UNITED STATES ENVIRONMENTAL PROTECTION AGENCY
REGION 10
1200 Sixth Avenue, Suite 900
Seattle, Washington 98101-3140

June 19, 2008

Re: Arkema CDF Evaluation

Re: LSS Response to June 19, 2008 Letter re: Arkema CDF Evaluation

Cross-Section A-A'
Conceptual Nearshore CDF Option

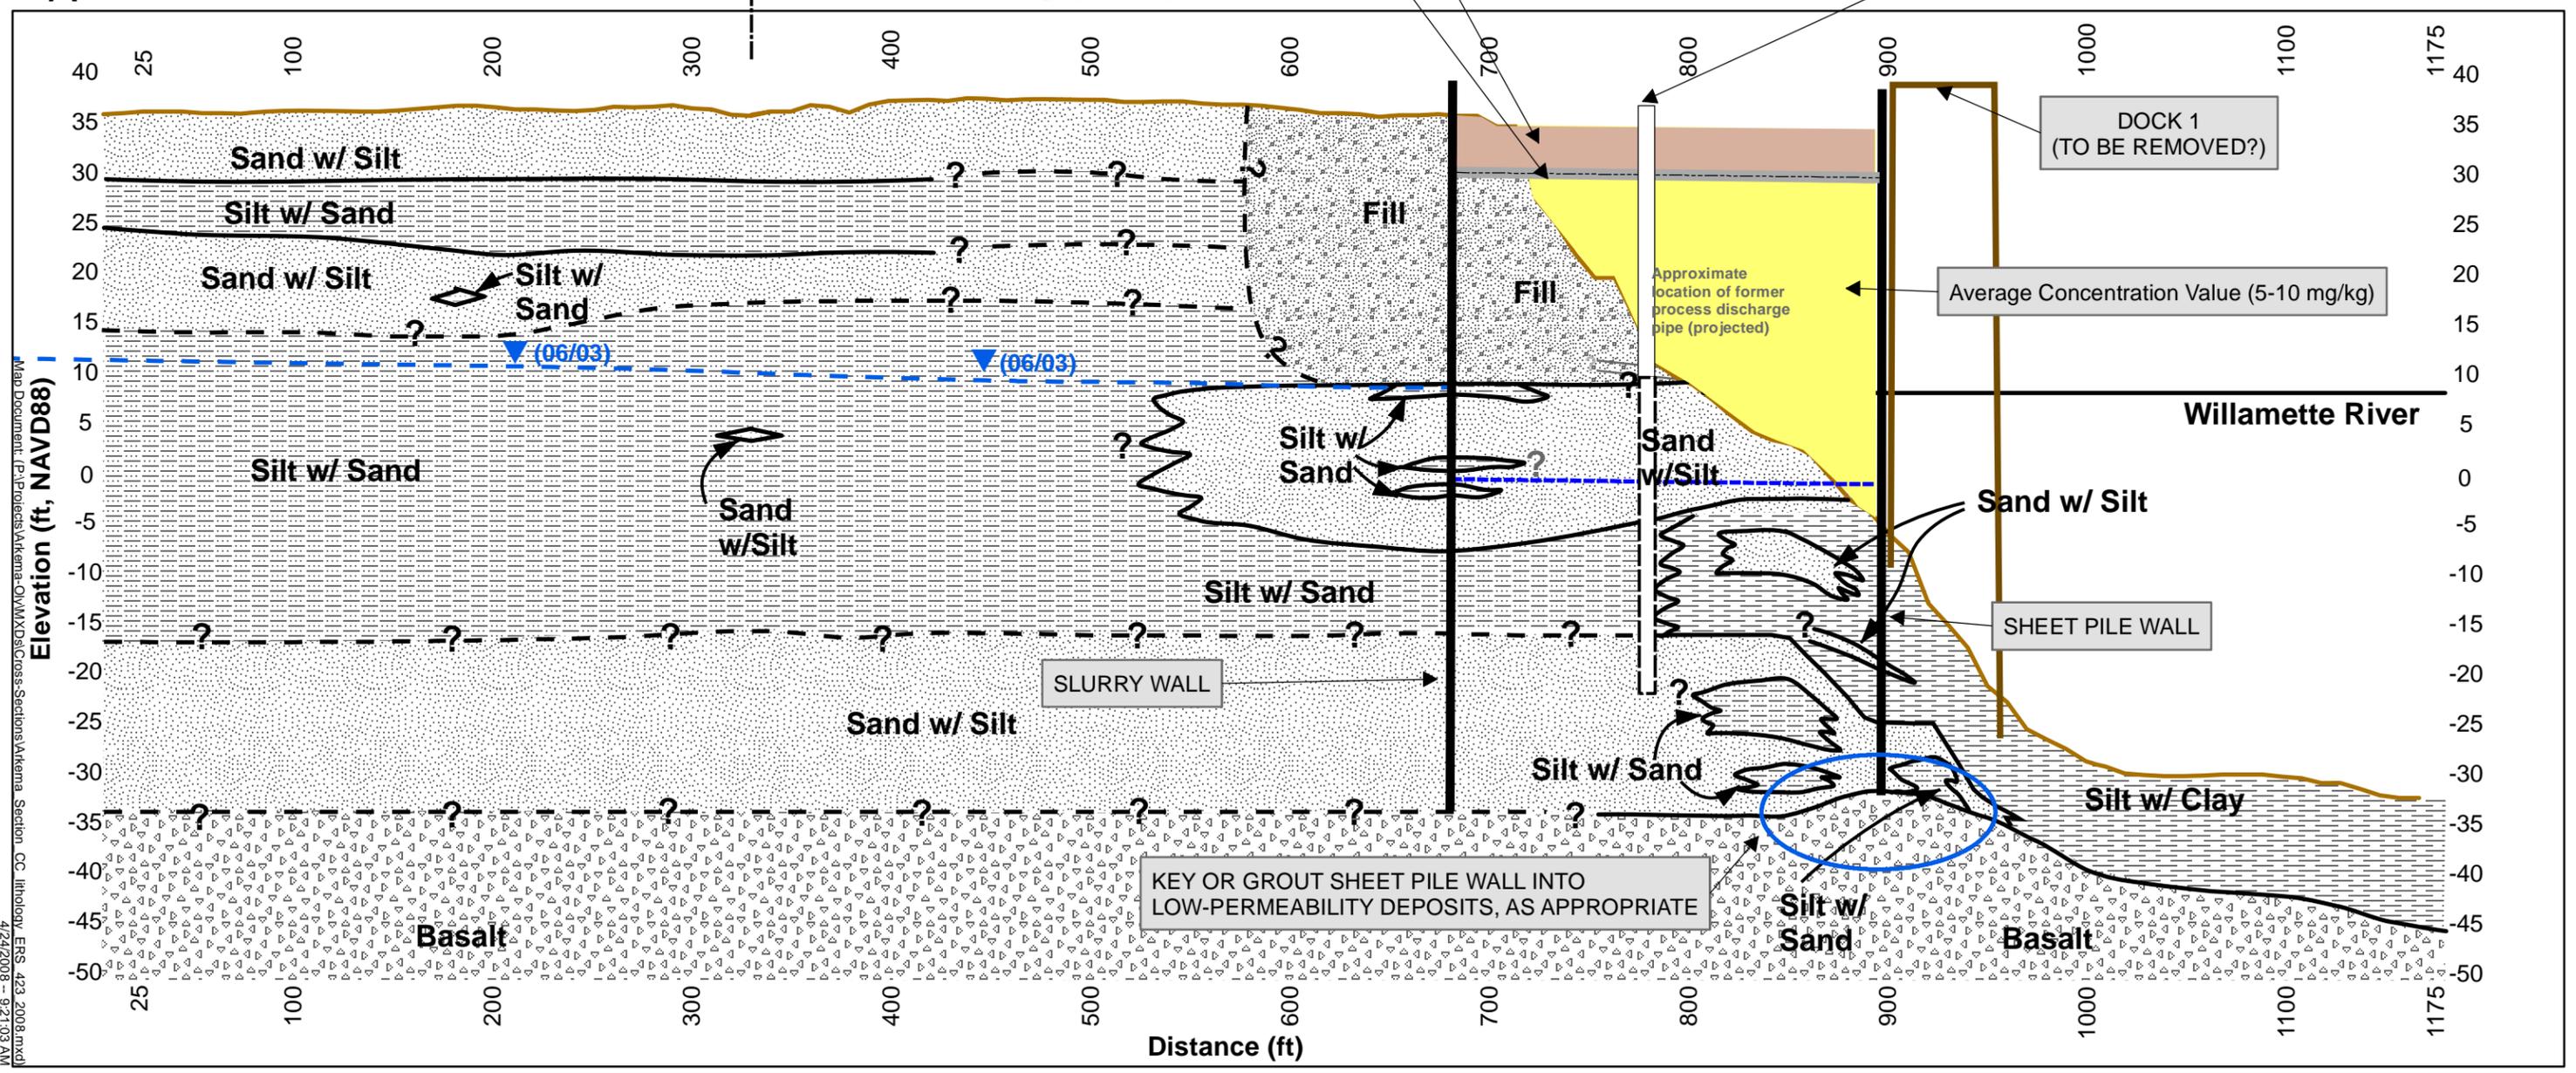
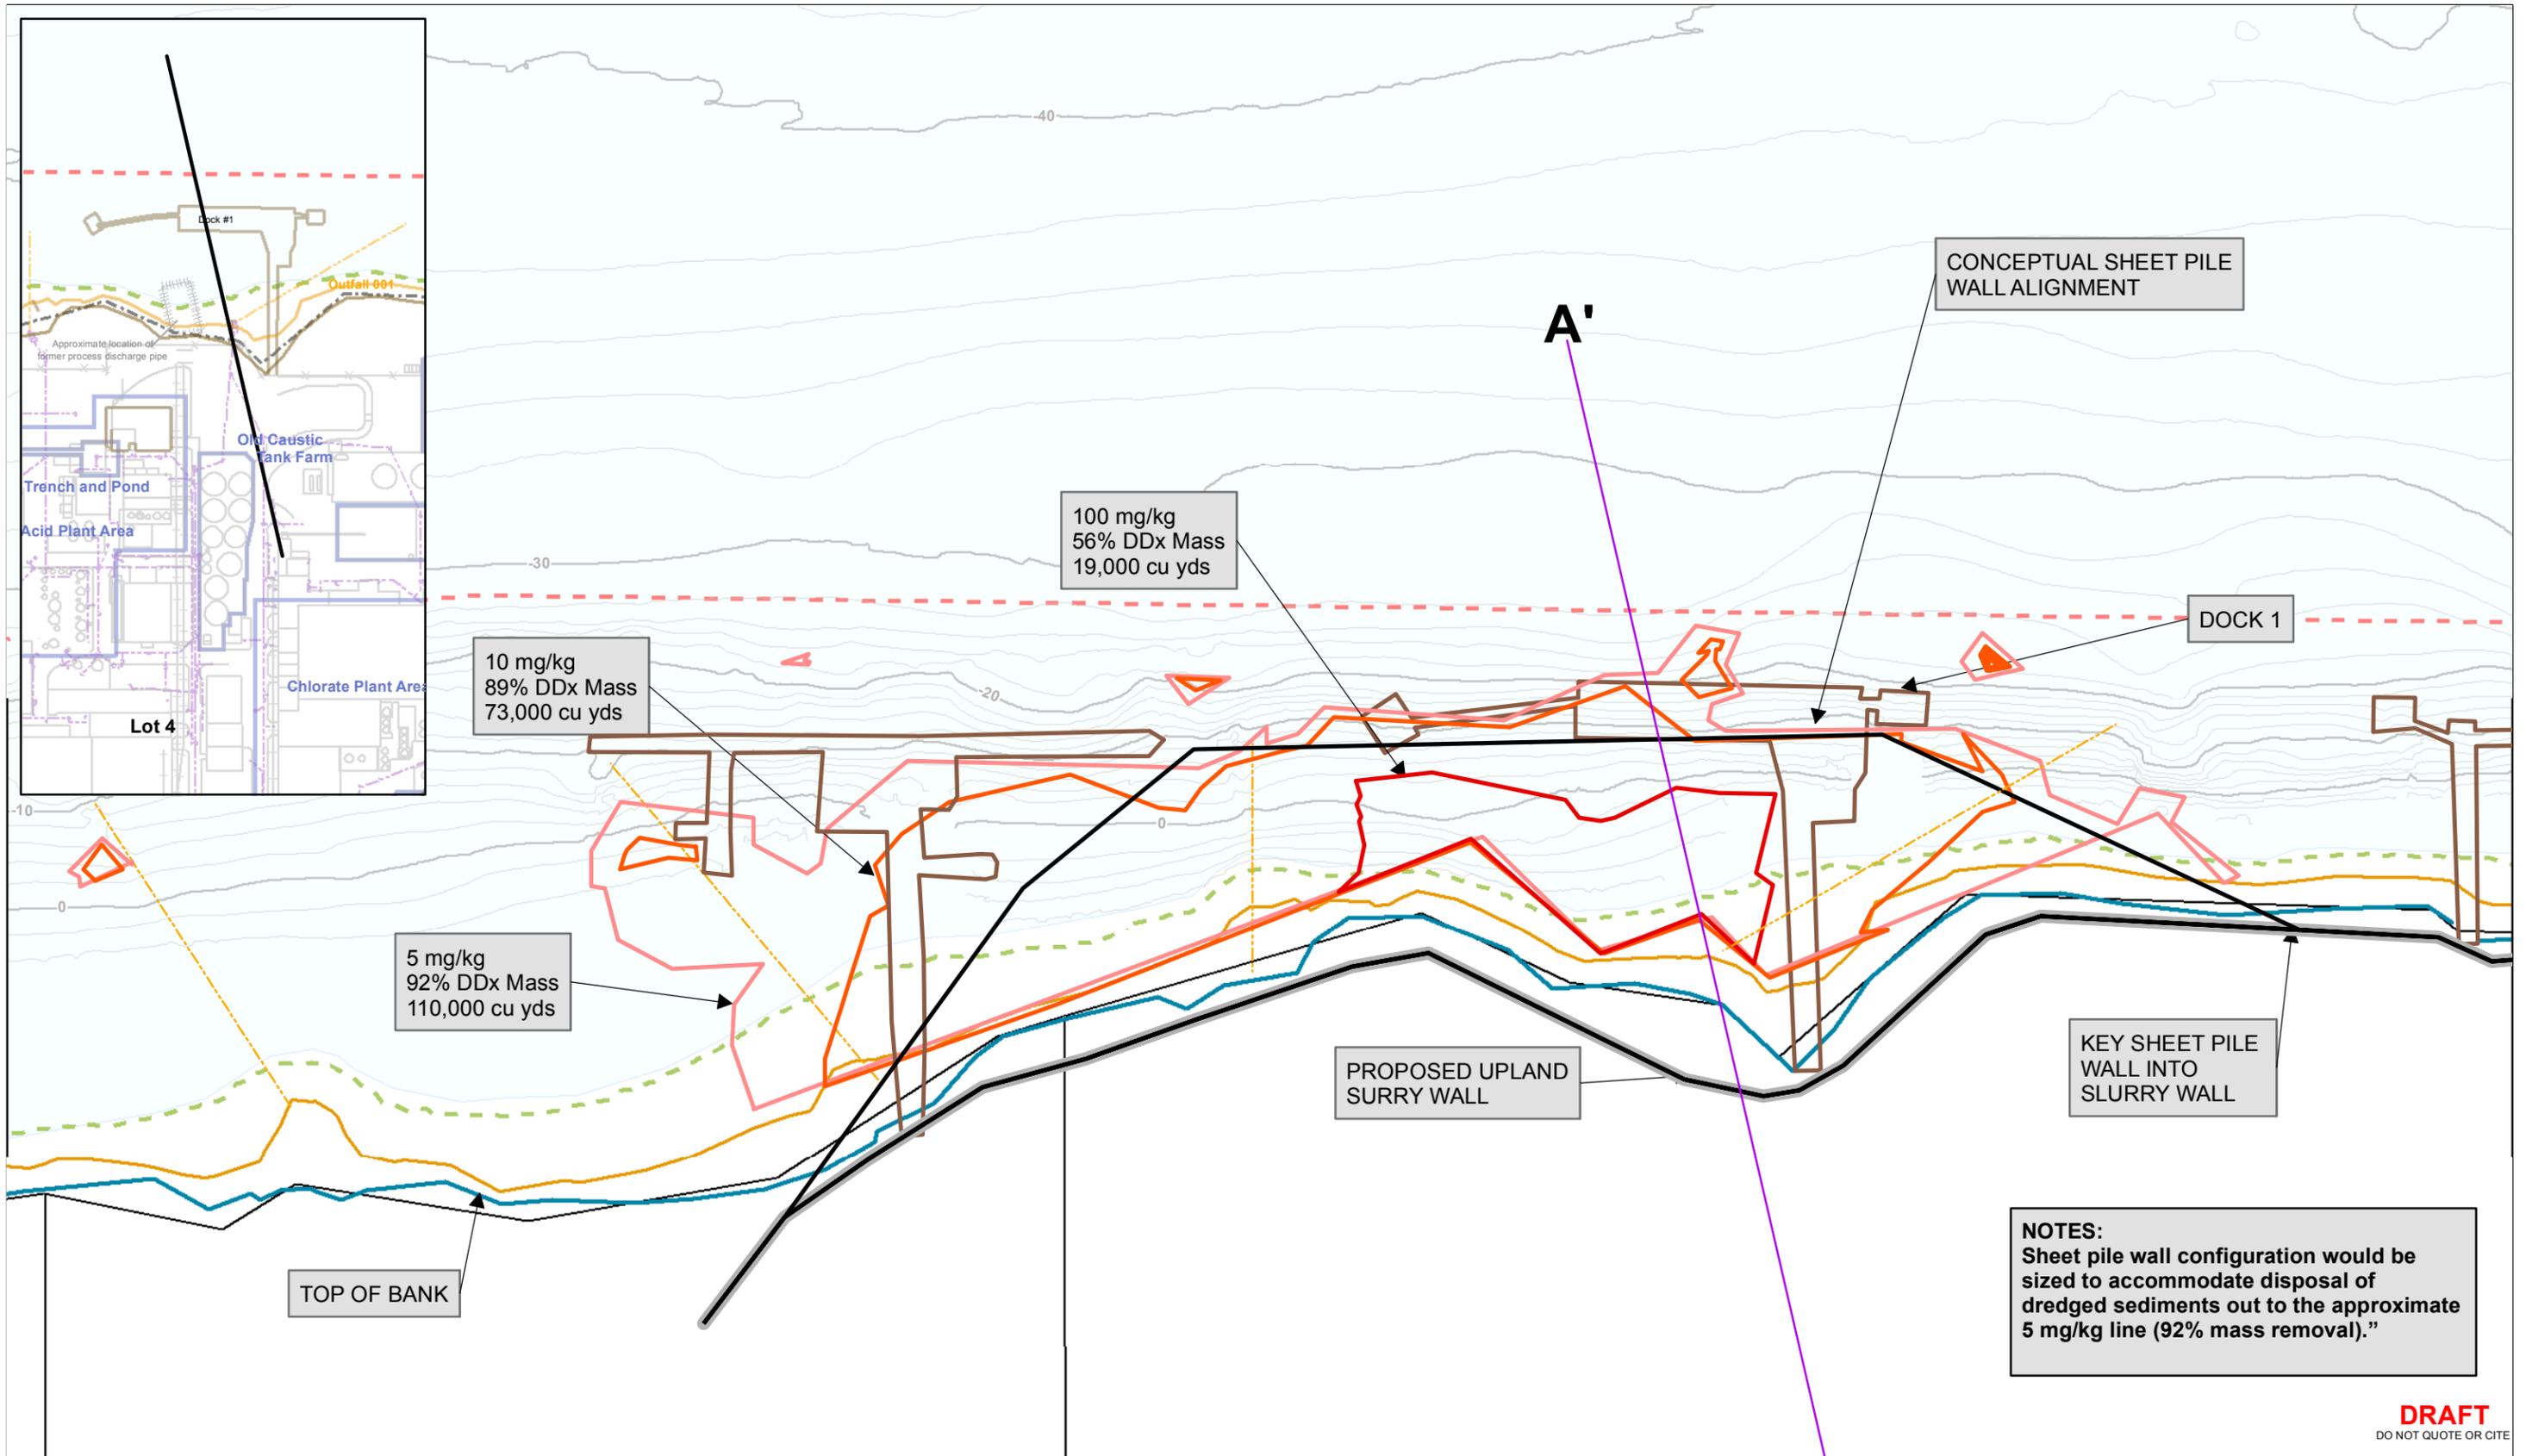
EPA states in its June 19th letter that it understands the CDF disposal alternative would involve placement of contaminated sediments within a “permanent CDF that is constructed in the water below the Ordinary High Water Mark” (OHWM). While the conceptual design for the CDF configuration to be evaluated in the EE/CA has not yet been fully developed, LSS anticipates that the CDF concept may involve placement of dredged sediment above the OHWM (please refer to the attached conceptual CDF profile figure)
